Access Compliance Report

Public Rights-of-Way

(Curb Ramps)

Intersection ID: 18011	Main Street: PARK_RD	Cross Street: HEATHER_LN	Location: NW
ADA ID: 9793DEF24D88	Ramp Type: BlendTrans2	Initial Pass/Fail: Fail	Overall Compliance: No
Codes/Mitigation Info/Possible Solution		Field Measurements/Component Compliance	
Severity Score: 33.75

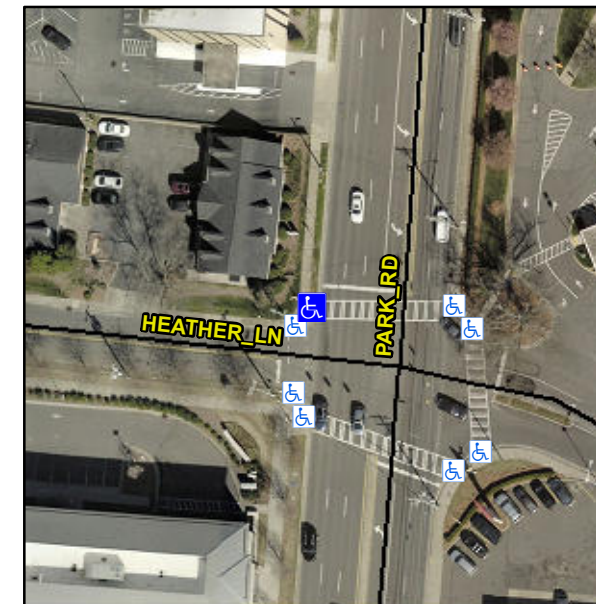
Not Found, R304.5.1, R304.5.3

Compliance	Description	Data	Compliance	Description	Data
N/A	Ramp Length (in)	117.0	Yes	BlendTrans Slope (%)	1.5
No	Ramp Width (in)	46.5	No	BlendTrans XSlope (%)	7.4
N/A	Flare Type LT	N/A	N/A	Flare Type RT	N/A
N/A	Flare Slope LT (%)	N/A	N/A	Flare Slope RT (%)	N/A
N/A	Flare Traversable LT?	N/A	N/A	Flare Traversable RT?	N/A
N/A	Landing Length (in)	N/A	N/A	DWS Provided?	N/A
N/A	Landing Width (in)	N/A	N/A	DWS Contrast?	N/A
N/A	Landing Slope (%)	N/A	N/A	DWS Length (in)	N/A
N/A	Landing X Slope (%)	N/A	N/A	DWS Full Width?	N/A
N/A	Landing Curb? (Y/N)	N/A	N/A	DWS Offset (in)	N/A
N/A	Shared Landing?	N/A			
N/A	Gutter Ponding?	N/A	N/A	Gutter Slope (%)	N/A
N/A	Gutter Lip Ht (in)	N/A	N/A	Gutter X Slope (%)	N/A
N/A	Painted X Walk1?	Yes	N/A	Painted X Walk2?	N/A
	X Walk 1 Direction	To E		X Walk 2 Direction	N/A
	X Walk 1 Width (in)	105.0		X Walk 2 Width (in)	N/A
	X Walk 1 Slope (%)	4.4		X Walk 2 Slope (%)	N/A
	X Walk 1 X Slope (%)	2.4		X Walk 2 X Slope (%)	N/A

N/A	Ramp inside XWalk1?	Yes	N/A	Ramp inside XWalk2?	N/A
	Road Slope (%)	2.4		Clear Space?	N/A
	Road X Slope (%)	4.4	N/A	Clear Space to XWalk (in)	N/A
N/A	Any Obstructions?	N/A	N/A	Storm Grate/Utility Hazard?	N/A
	Obstruction Type			Storm Grate/Utility Type	
		N/A			N/A
			Yes	Surface Condition? (G/P)	Good
			No	Curb Slope (%)	8.5

Remove & Replace Curb Ramp With Two New Directional Ramps or Equivalent.
